1545 WEST 8<sup>TH</sup> AVENUE (COMPLETE APPLICATION)  
DE415620 - ZONE C-3A

- **Proposal:** To construct an eight-storey Multiple Dwelling building containing 18 dwelling units all over two levels of underground parking, having vehicular access from the lane.

**DEVELOPMENT PERMIT STAFF COMMITTEE RECOMMENDATION: APPROVE**

PLAN  
ROOF

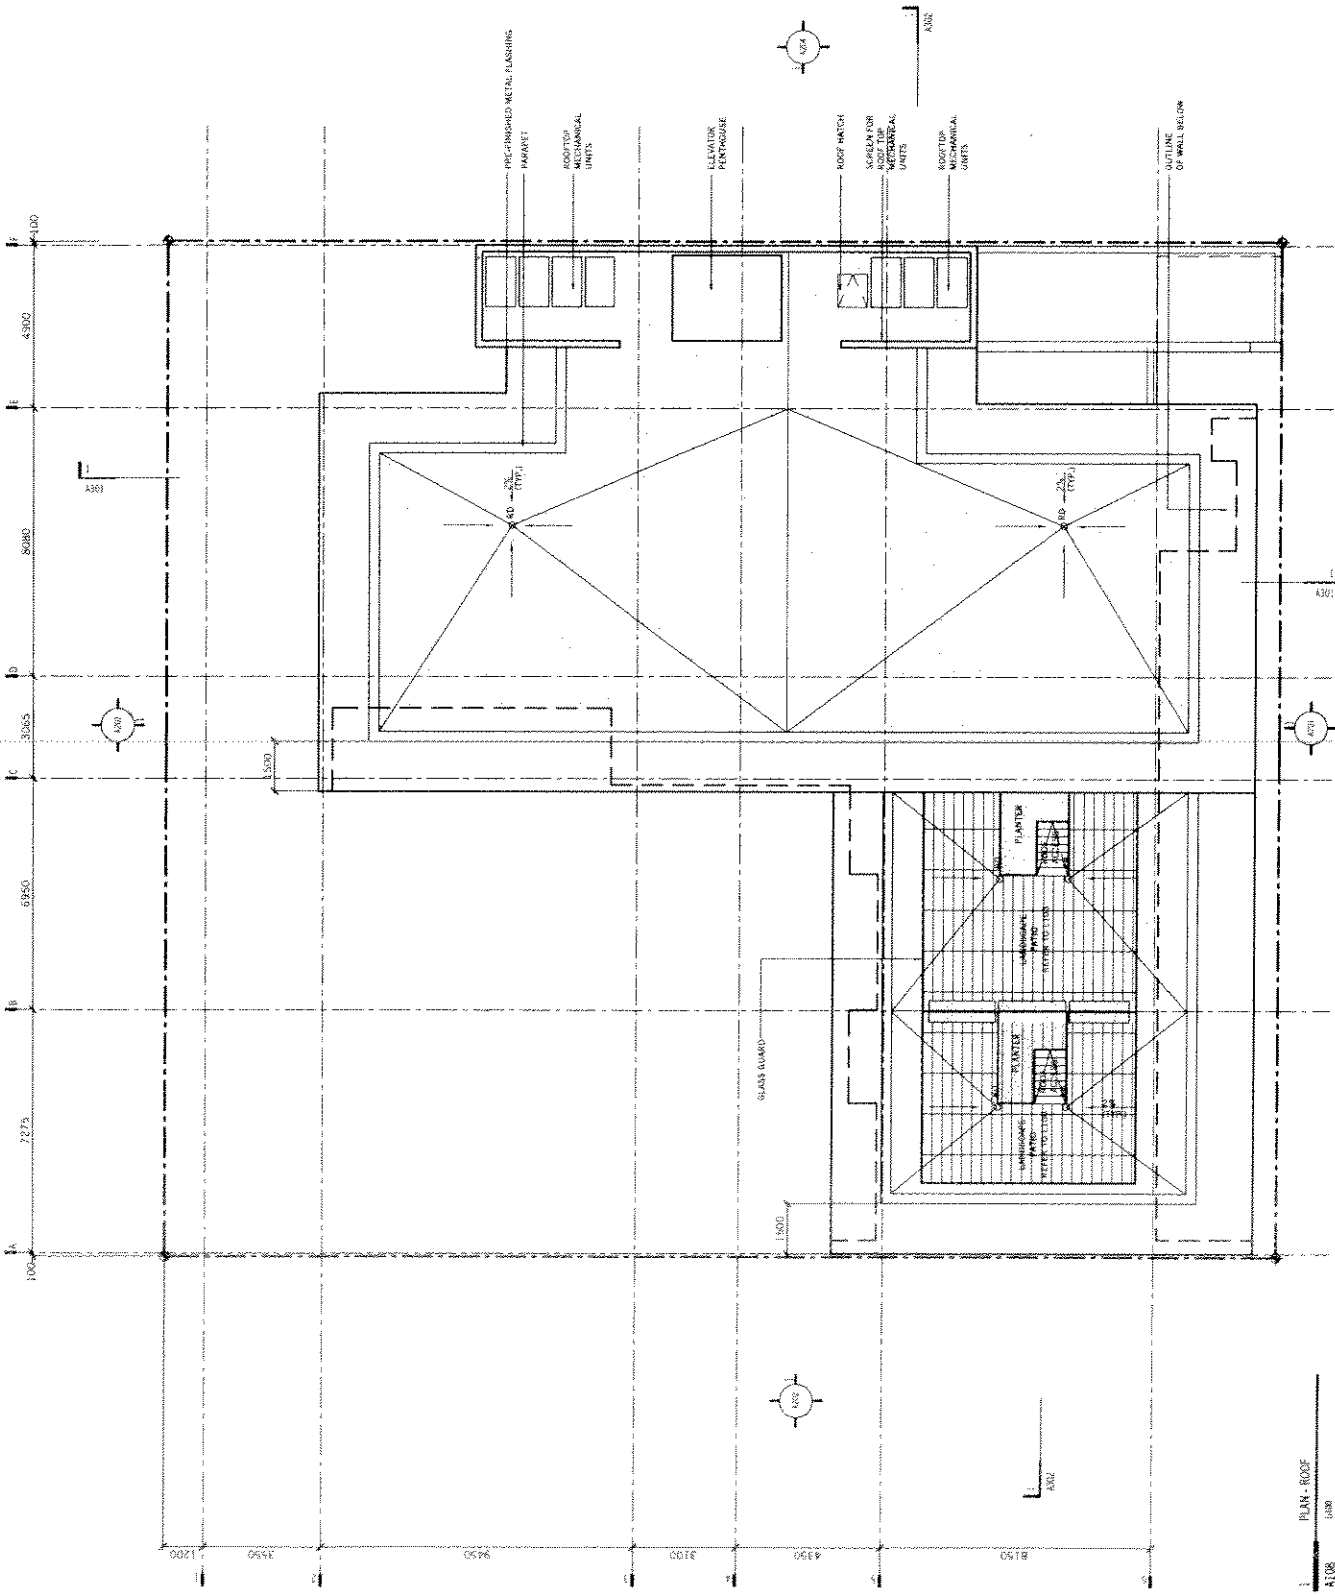
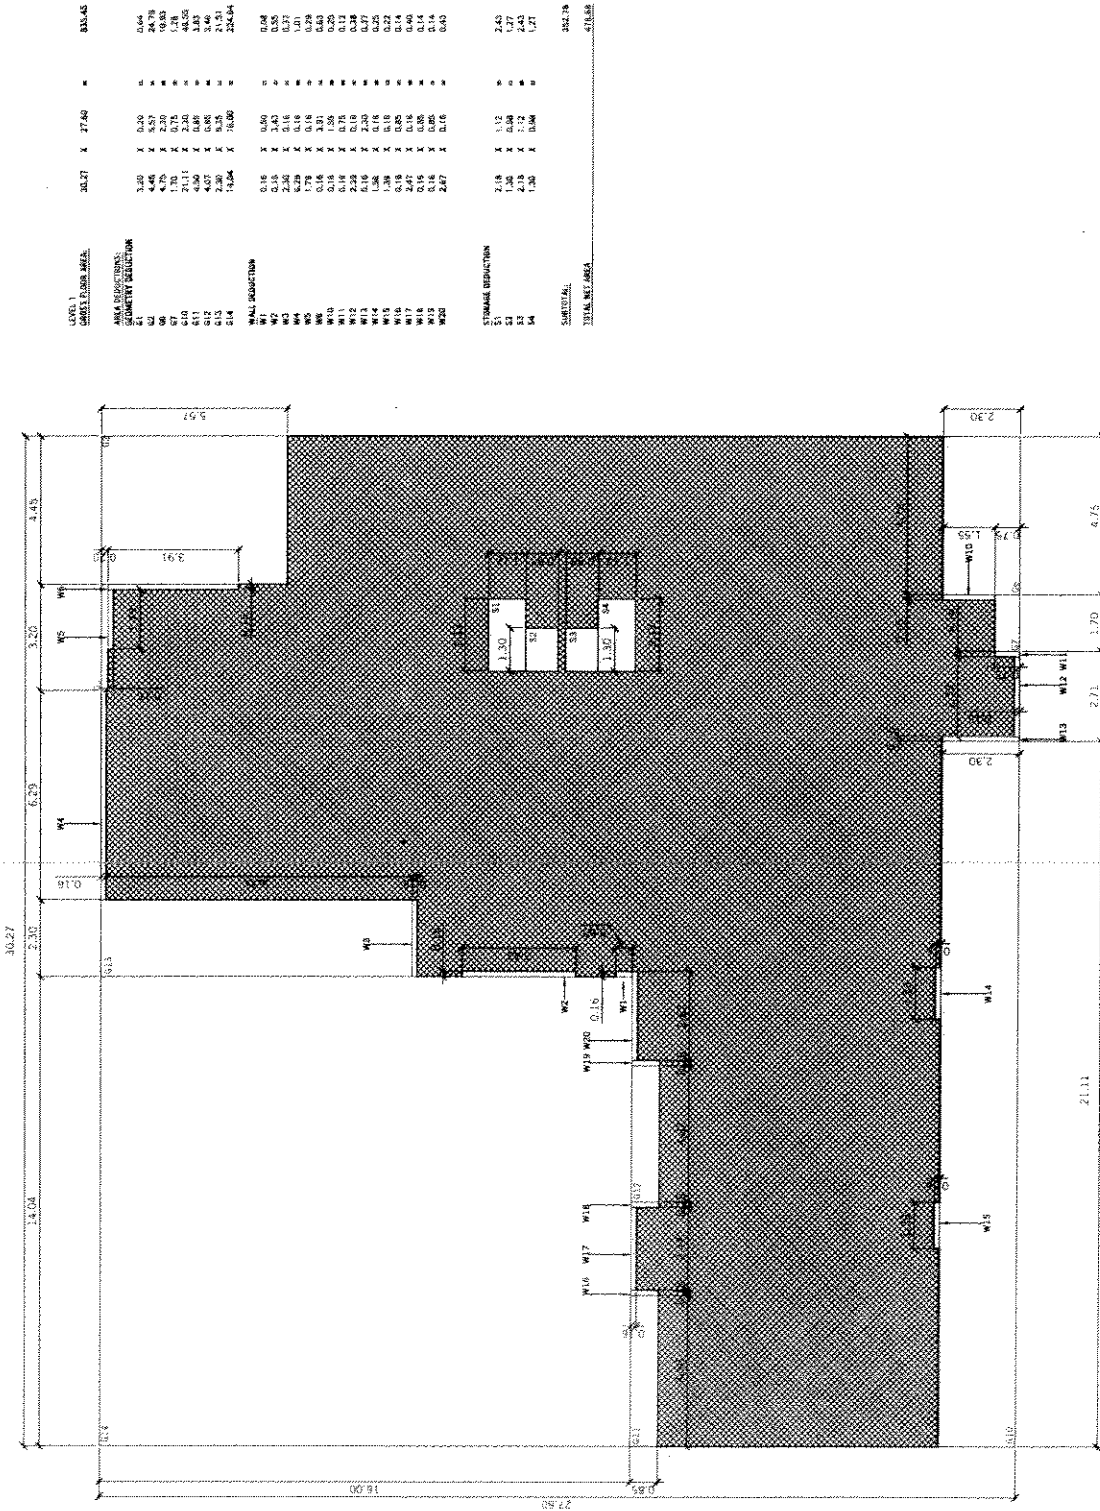
1.2 design development to address overlook of the upper roof level from adjacent buildings, providing a pleasing and visually interesting roofscape;

**Note to Applicant:** Through patterning and material variety provide a roofscape that is pleasant to look upon. Consider an extensive or intensive green roof. Roof access should be restricted for maintenance purposes and accessible by stair only. No additional height beyond the current proposal is permitted.

1545 W 8TH AVE LANDSCAPE  
VANCOUVER, BC PLANTER DETAILS  
2010-041

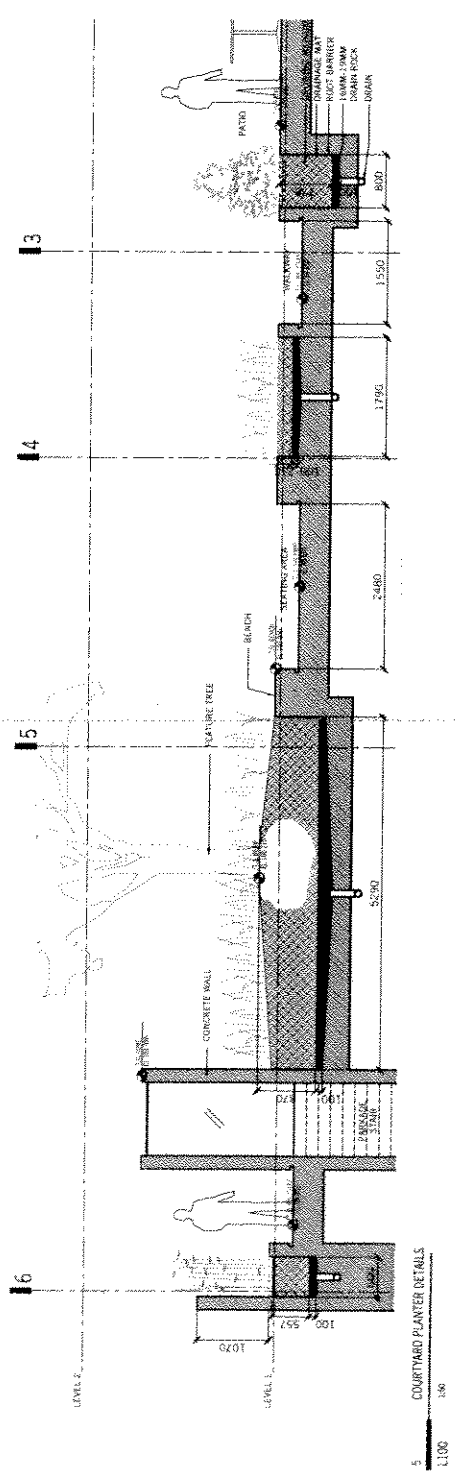
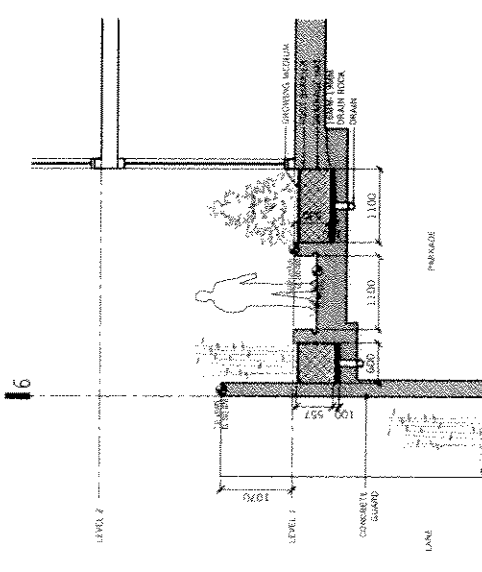
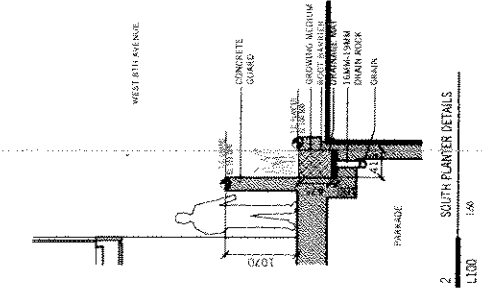
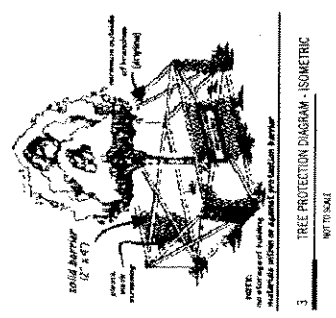
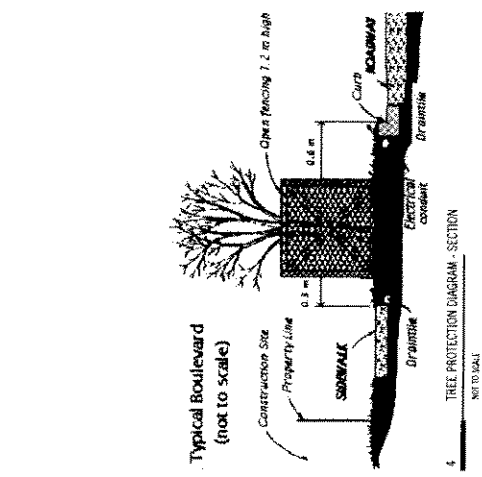
A.1.12 increase the width and depth of the proposed tree perimeter planter located at the west side of the second floor landscaped courtyard to provide more space for tree roots and for sustained health of the proposed Birch tree planting;

**Note to Applicant:** The planter should be expanded to have a minimum depth and width of 80 cm. Provide a large-scale section illustration planter detail at 1:50. Revise the planting plan graphics to more accurately illustrate the location of the 8 proposed Birch trees.
